AGENDA FOR REGULAR MEETING VILLAGE OF TINLEY PARK PLAN COMMISSION

**ITEM #1 PUBLIC HEARING – BETTINARDI EXPANSION, 7650 GRAPHICS DRIVE –
SITE PLAN APPROVAL AND SPECIAL USE FOR A SUBSTANTIAL
DEVIATION FROM A PLANNED UNIT DEVELOPMENT**

**MINUTES OF THE REGULAR MEETING OF THE
PLAN COMMISSION, VILLAGE OF TINLEY PARK,
COOK AND WILL COUNTIES, ILLINOIS**

PLAN COMMISSION STAFF REPORT

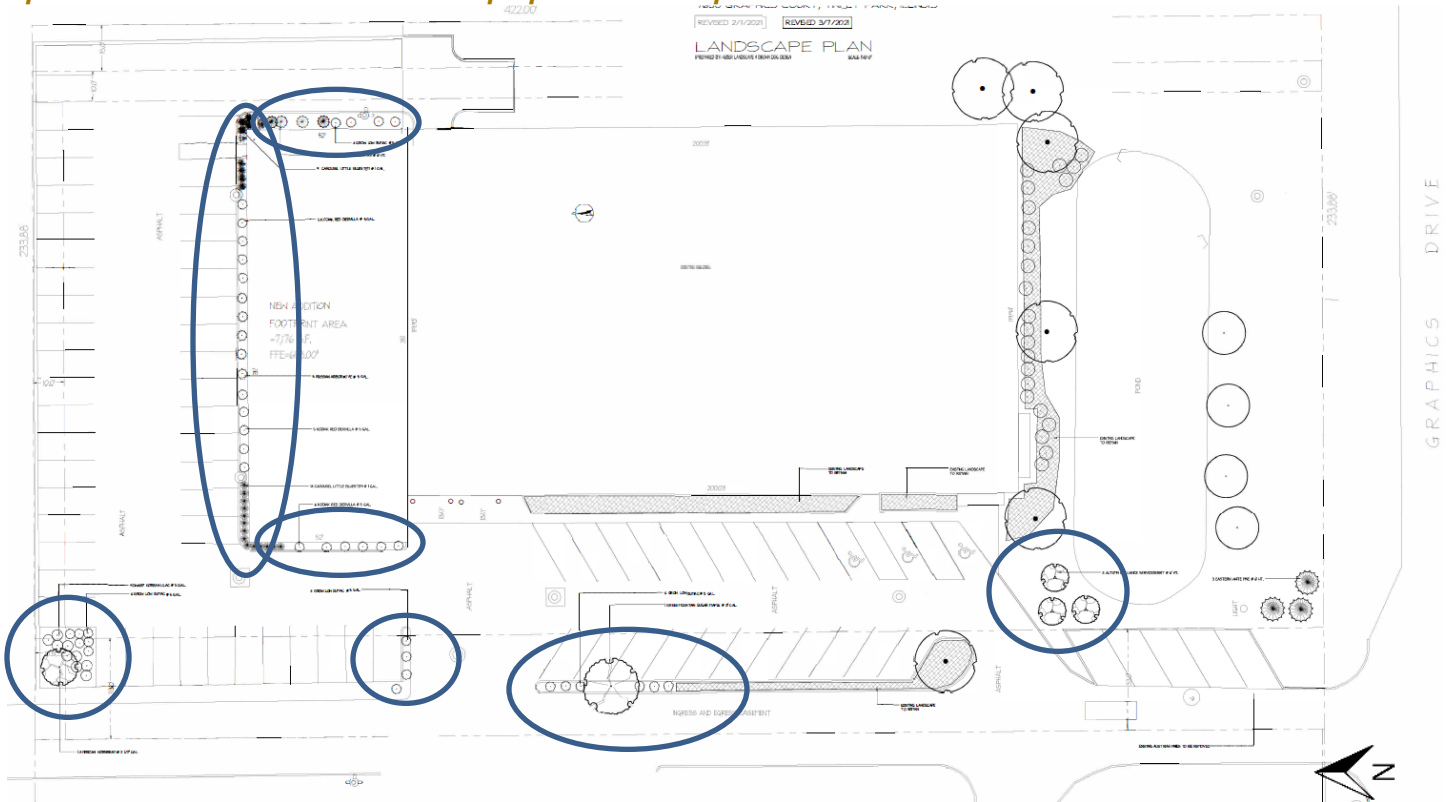
The front façade and pond area are attractively landscaped but one tree will be removed where the new parking location is proposed. New landscaping is being proposed along the building addition's foundation, the main drive aisle, and within the parking lot. The new landscaping and curbing around the foundation of the building also helps inadvertent collision of vehicles into the building.

Open Item #5: Review and discuss the proposed Landscape Plan.

PROPOSED GEOMETRIC SITE PLAN

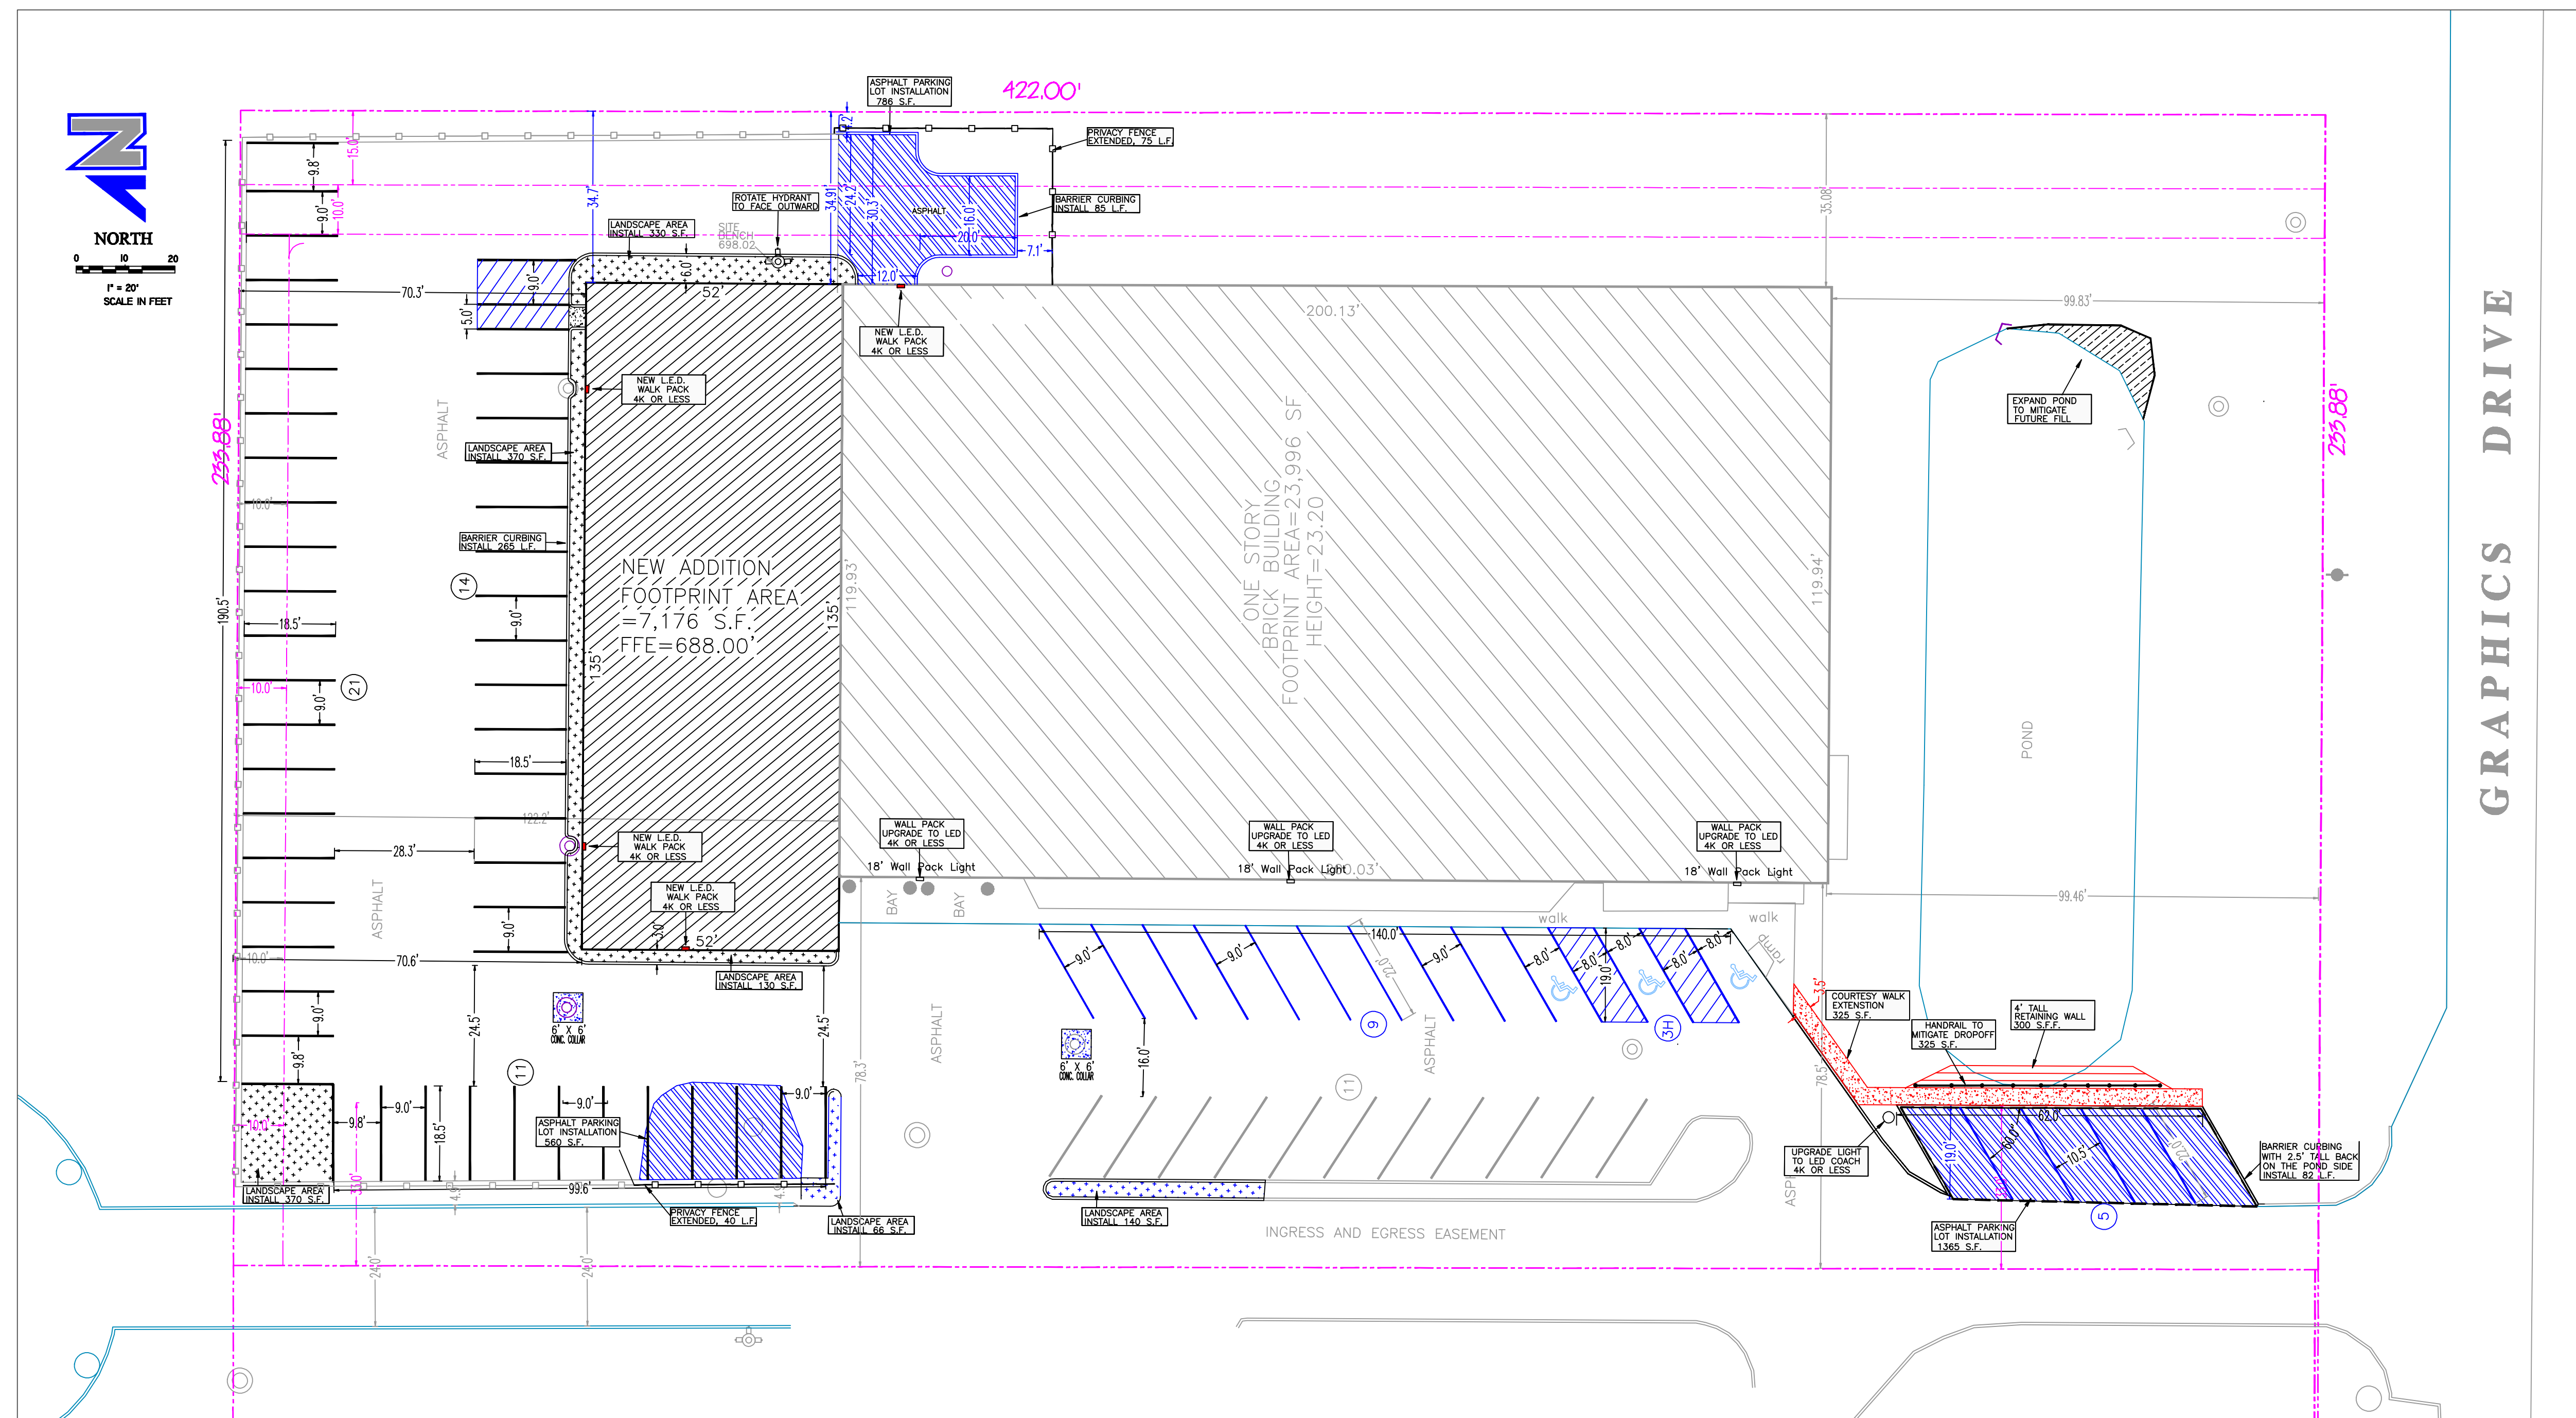
The Plan Commission indicated at the workshop meeting that if the front yard parking was to be requested as an Exception, a walkway should be provided in front of the new parking stalls to the entrance. The walkway ensures safe pedestrian travel from those stalls and avoids visitors walking in the main roadway/aisle to access the front entrance. The revised site plan is submitted and attached (dated 3-26-21) with a walkway included on the plan. The walkway will require a retaining wall and handrail to be installed due to the slope of the pond. Revised preliminary engineering is still needed but can be submitted with the final permit documents.

Plan Commission concurred with staff that the photometric plan needed to include the new stalls and show adequate lighting for security purposes. The revised site plan indicates a new light pole will be added near the new parking stalls. A revised Photometric Plan and cut-sheet for the light pole/fixture have not been received. Staff believes that the lighting review can be resolved with the permit submittal and a recommended condition was included to clarify the need to review the missing lighting information.

Above: Revised Site Plan showing sidewalk and new light pole around new visitor parking stalls.
